STRUCTURAL EVALUATION OF THE DIESEL GENERATOR BUILDING -
ASSESSMENT OF THE STRUCTURAL PERFORMANCE
CAPABILITY AND SERVICEABILITY AS POTENTIALLY AFFECTED
BY SETTLEMENT INDUCED CRACKING

TERA CORPORATION

TOPIC TITLE Civil/Structural Design Considerations, Foundations, Concrete/Structural Steel TOPIC NO. 111.5-2, 111.6-2, PAGE 1 OF 3
 ENGINEERING EVALUATION Structural Eval. of the Diesel Generator Bldg CONT. ID. NO. 3201-001-031 REV 0 DATE 12/30/83

FIGURE 6-2
 DIESEL GENERATOR BUILDING
 SETTLEMENT MARKER LOCATIONS

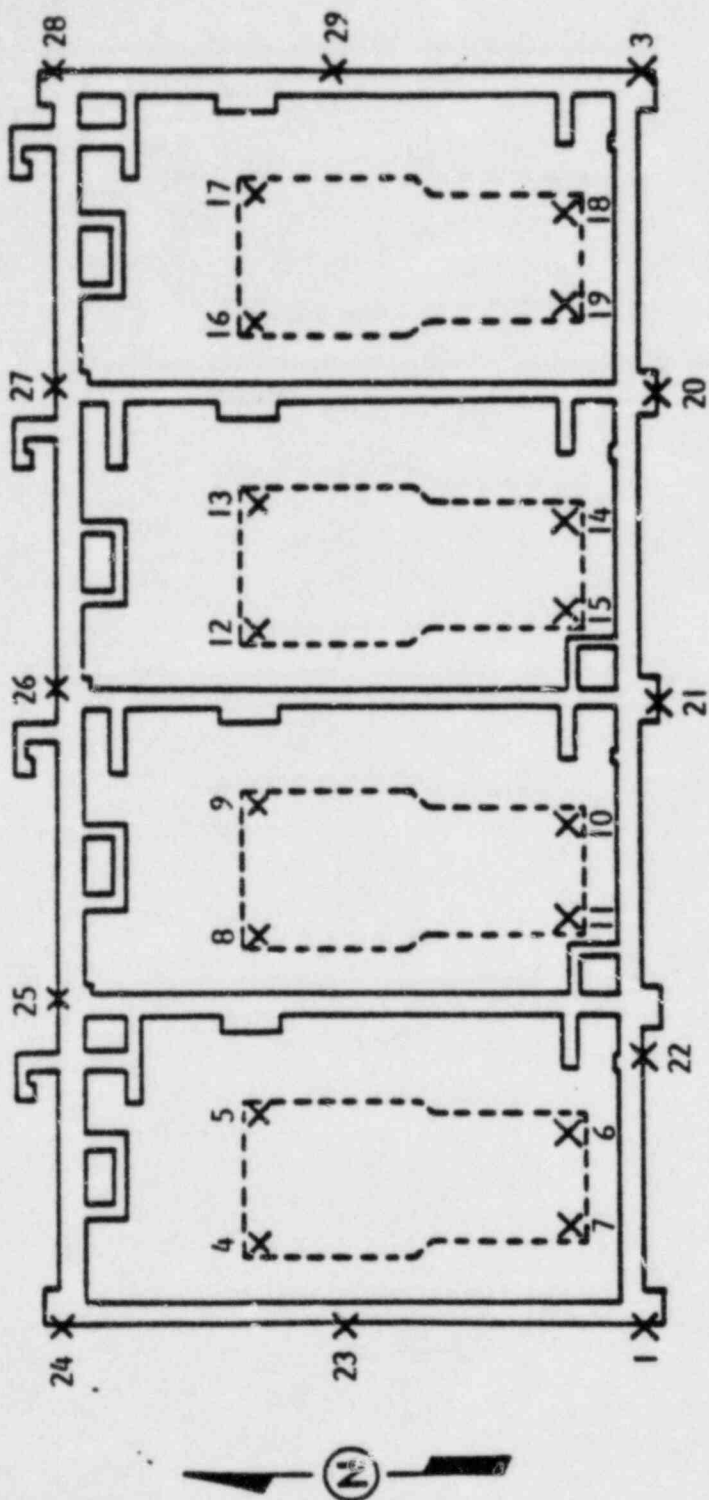
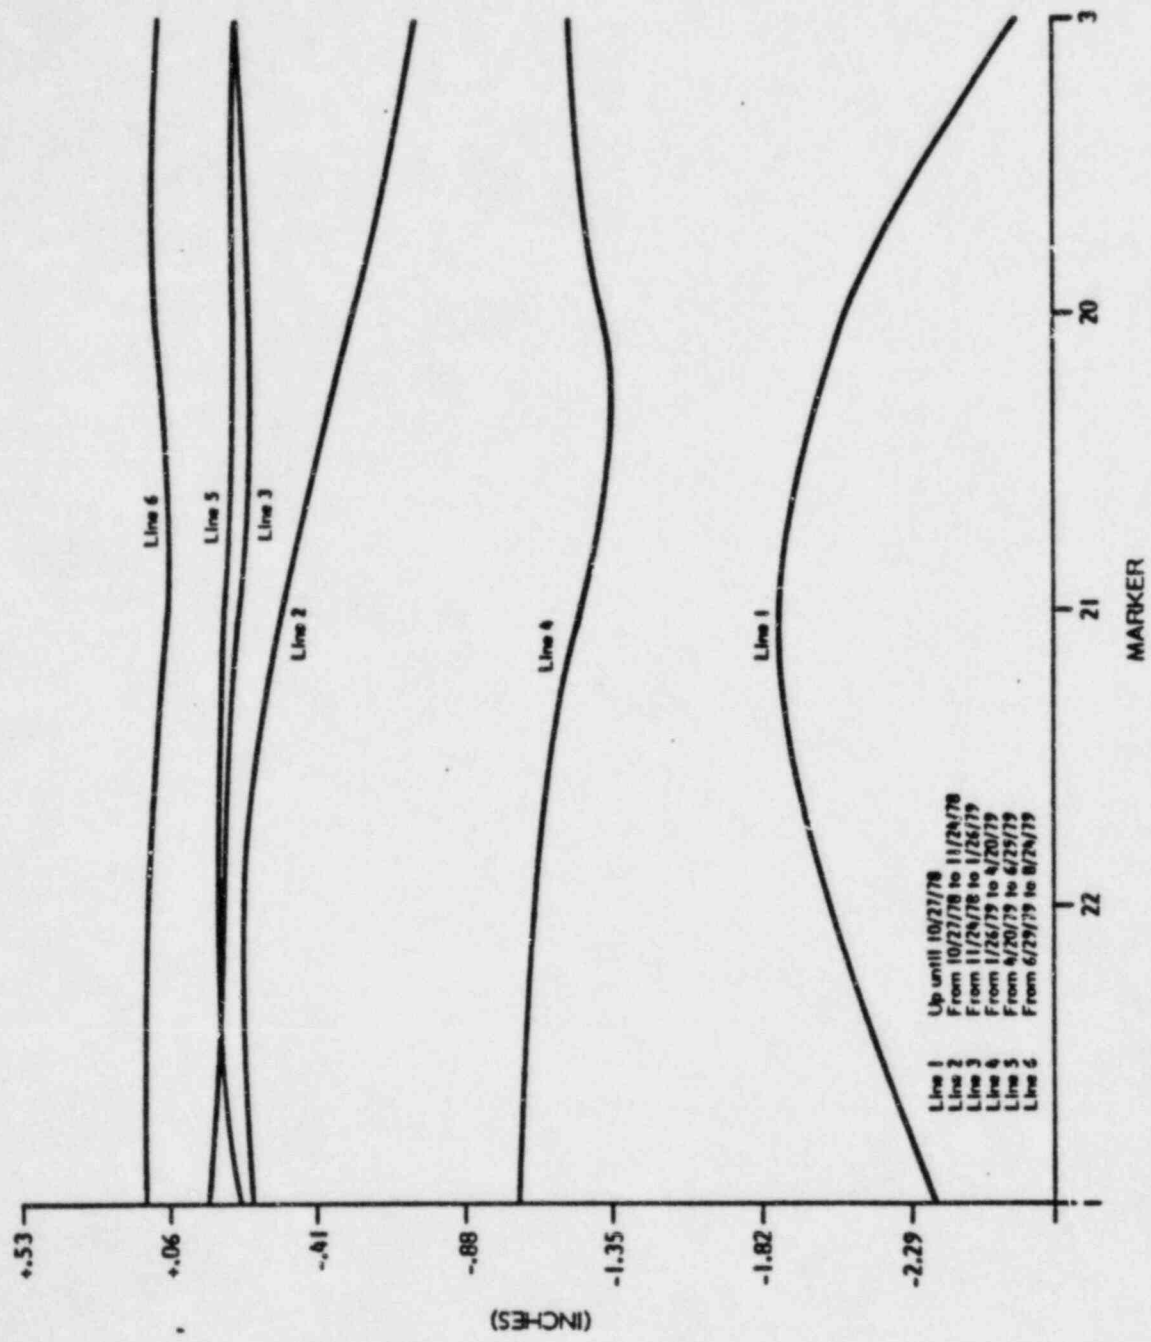
The building settlements have been monitored at close intervals during the construction period and thereafter. Figure 6-2 presents the location of the settlement markers indicating where survey measurements are taken. The data spans over a period of 5 years with measurements taken approximately every other week. This large amount of data allows one to follow the settlement history through the stages of construction, duct bank isolation, surcharge period, dewatering, and up through the present. It also provides a means of assessing potential random and systematic errors in the measurements. The Midland project has concluded that significant errors exist in the measurements due to a variety of circumstances. A study of these data is presented in the following section.
